Docket Item # 5
BAR CASE # 2017-00131

BAR Meeting
June 7, 2017

ISSUE: Request for alterations, waiver of fence height requirement, and waiver of vision clearance.

LOCATION: 802 Green Street

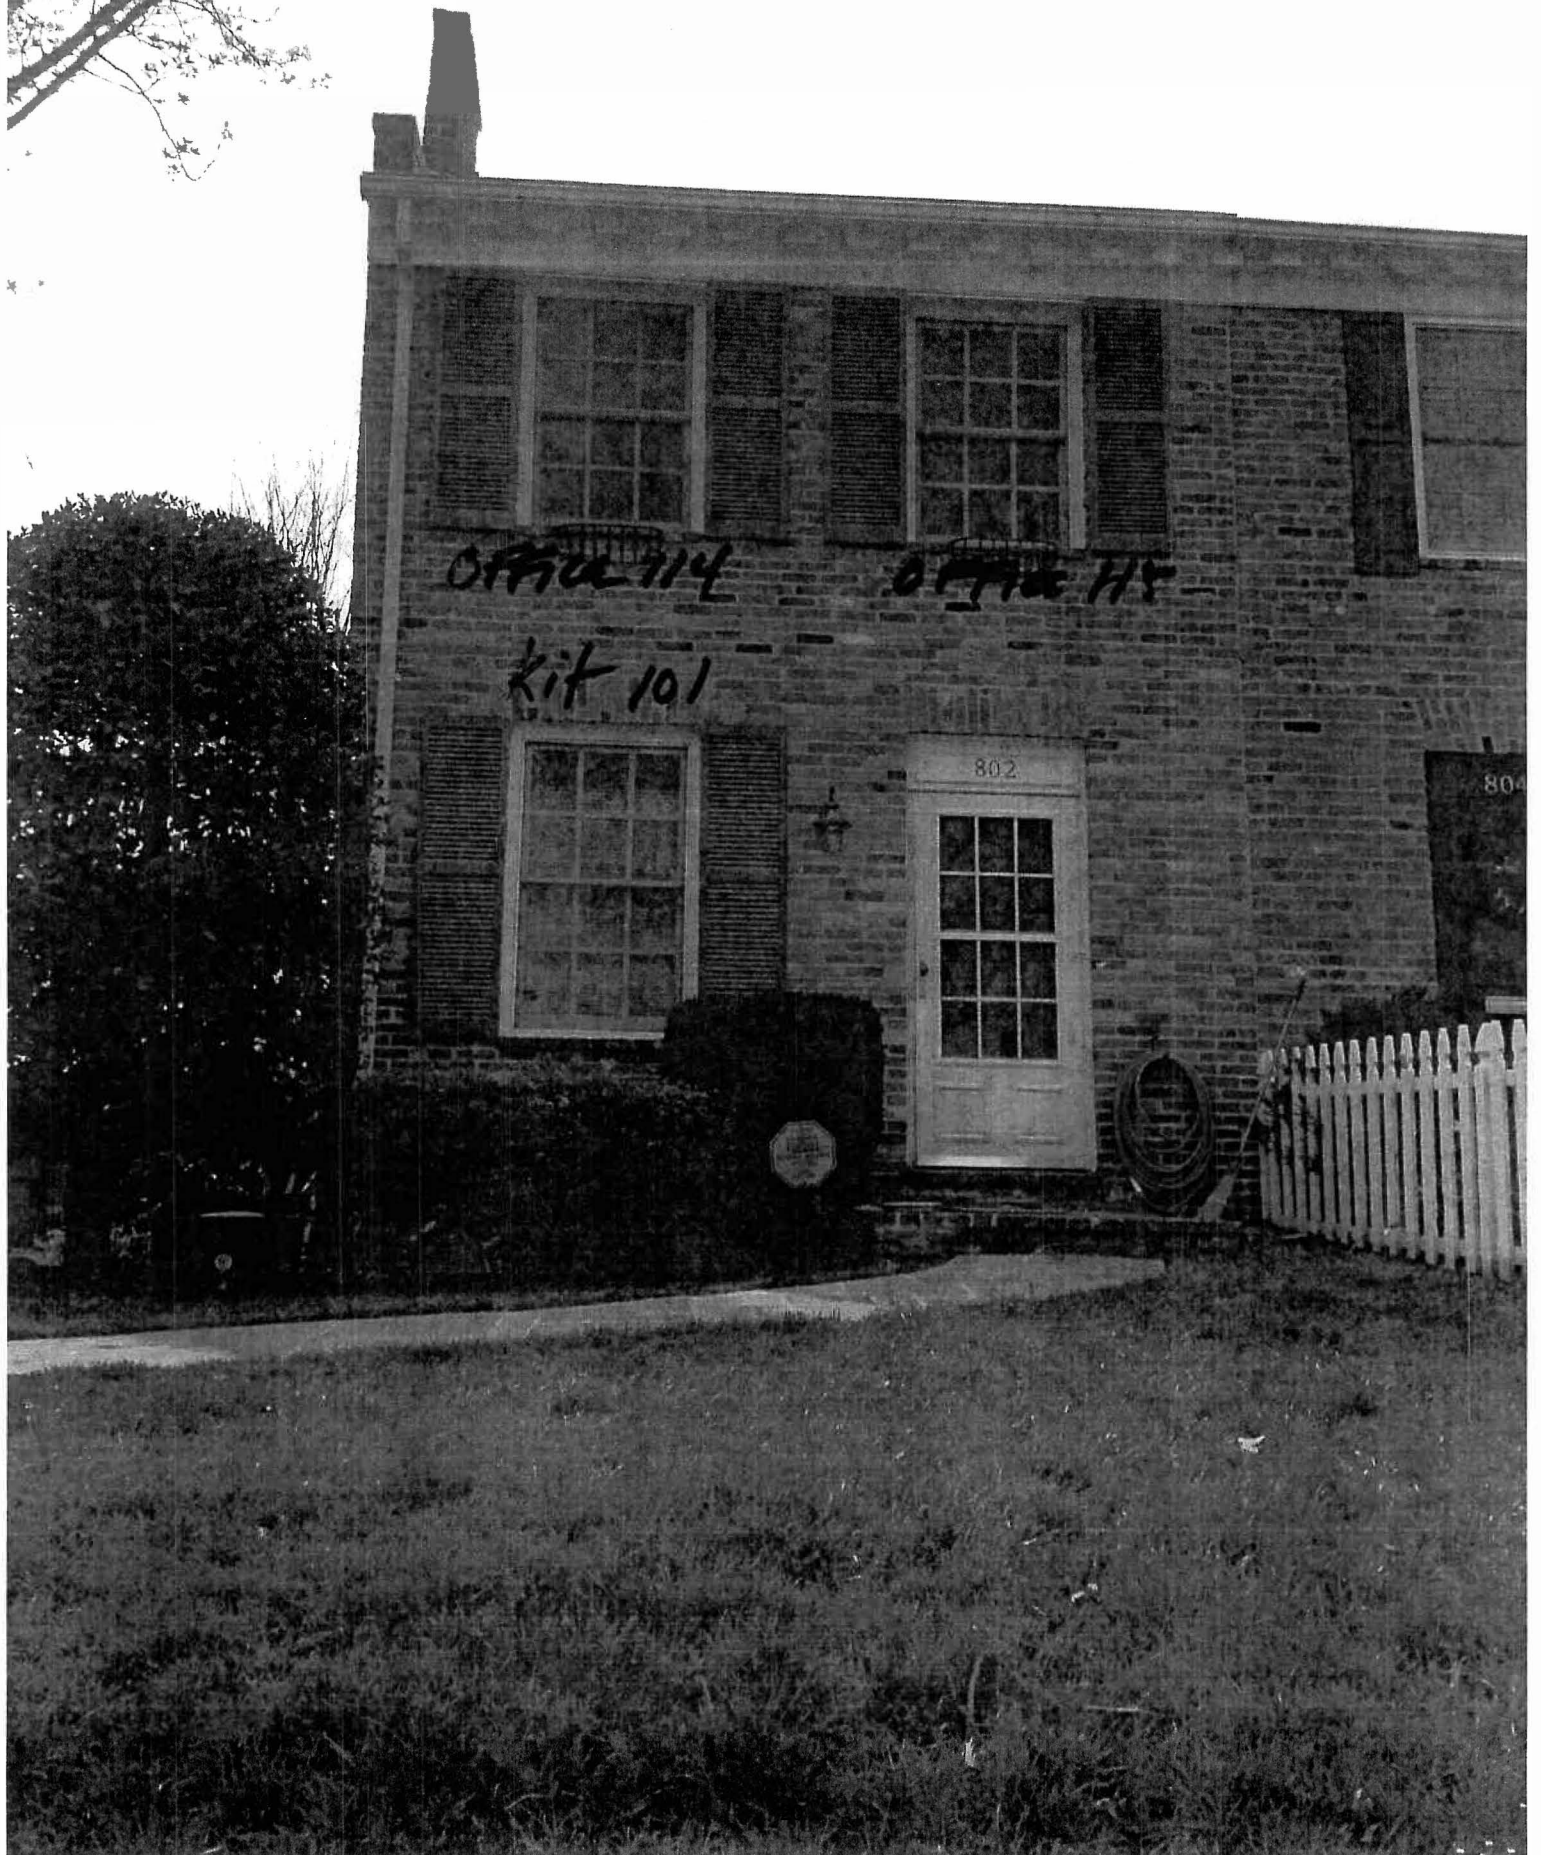
However, the application states that the size, design and location of the windows and patio door will remain the same as the existing, though staff is unable to tell from the application materials what the proposed patio door actually looks like. The existing door is a hinged in-swing French door with vertical mullions separating it from the fixed sidelights on either side. The door and sidelights are part of a larger composition and align with the tripartite windows above. From the information provided, it does not appear that the proposed gliding patio door will do that.

1. The glazing on the windows must be clear, non-reflective and without tint. Low-E glazing is encouraged but the glass must have a minimum 72% visible light transmission (VLT). Low-E 272 generally meets these criteria. Muntins and spacer bars must comply with the performance specifications. Provide final specifications to confirm conformance with the Window Policy as part of the building permit process.
2. Plant additional shrubbery along the base of the retaining walls to lessen the visibility of the fence.
